**LESSONS LEARNED REPORT FROM THE THIRD  
NATIONAL FIRE PROTECTION ASSOCIATION (NFPA) 805  
PILOT PLANT OBSERVATION VISIT**

**Date:** November 6–9, 2006

**Location:** Progress Energy Headquarters, Raleigh, North Carolina

**Subject:** Risk-Informed, Performance-Based Fire Protection Transition Pilot-Plant Observation Visit – Raleigh, North Carolina

Figure 1. Multiple Spurious Post-Transition Inspections

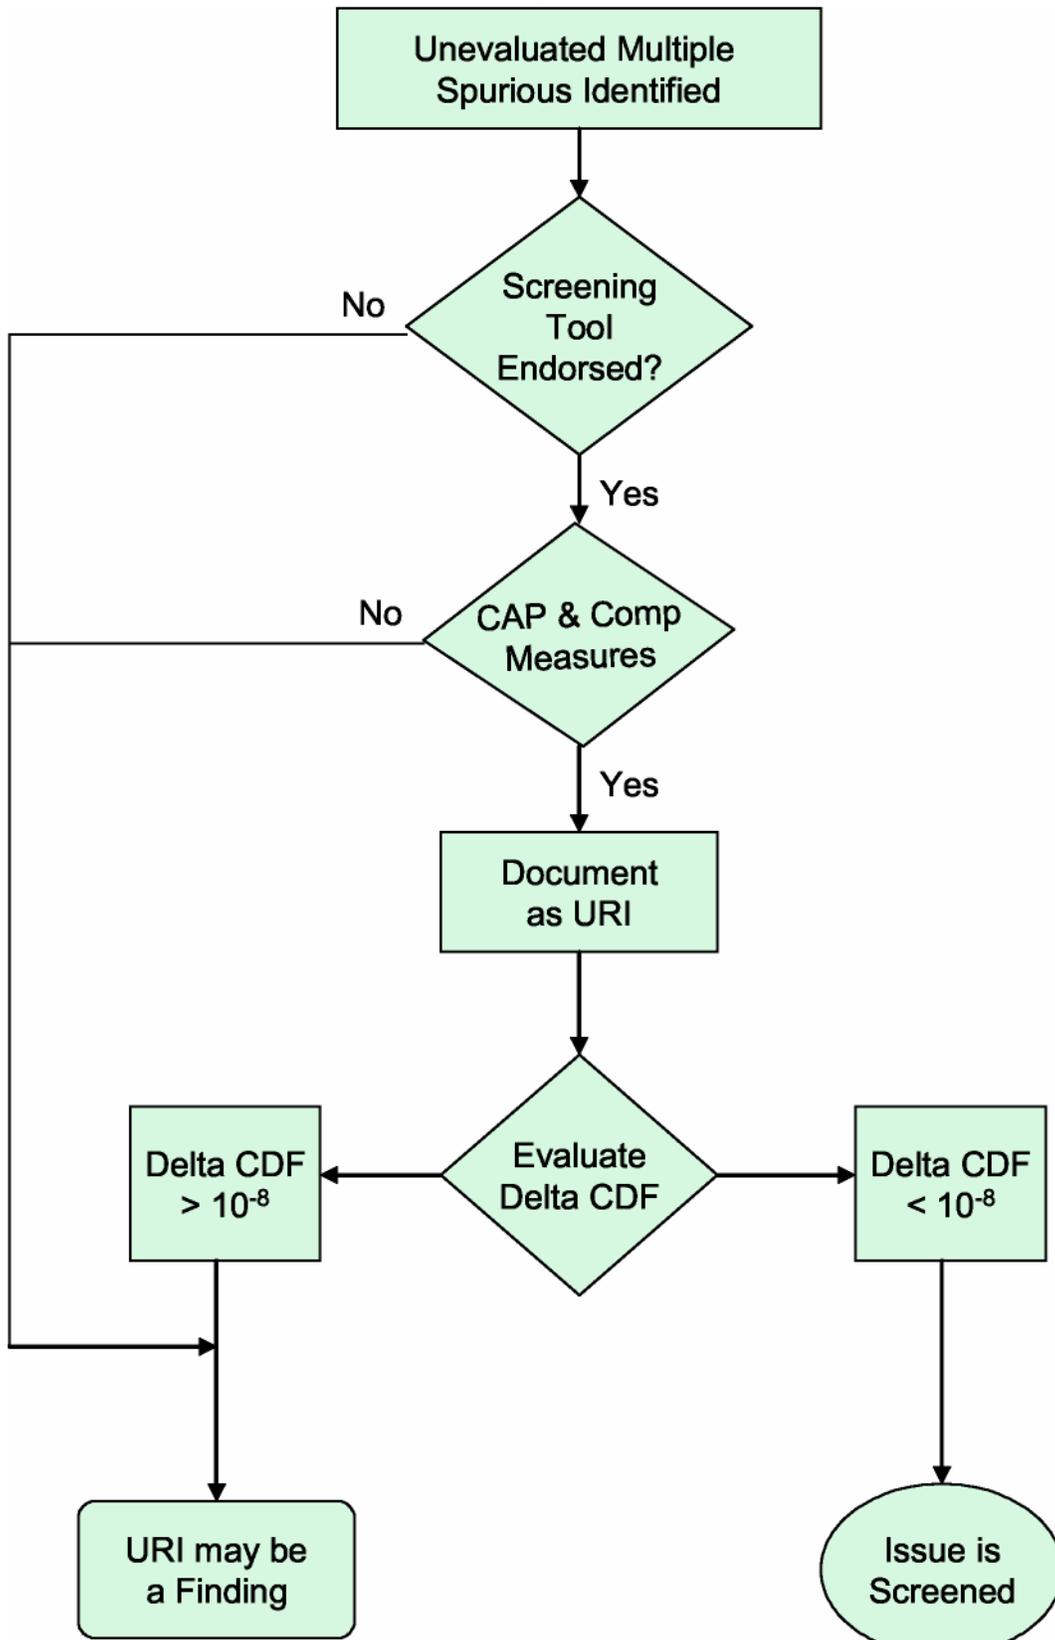
The NRC staff presented a flowchart during the March 2006 pilot plant observation meeting that illustrated how new multiple spurious operations (identified during inspections) would be treated. (See flow chart below.) The NRC staff also conveyed the following information during the meeting:

Chapter (IMC) 0612, and suggest development of new questions if necessary such that multiple spurious operations below a certain threshold are minor and treated accordingly.

**Resolution Action(s)/Action Party:** OPEN. Industry and pilot-plant participants agreed to review the flowchart, IMC 0612 questions, screening thresholds and provide feedback to the NRC at the next observation meeting. The industry may also submit an frequently asked questions (FAQ) on the issue.
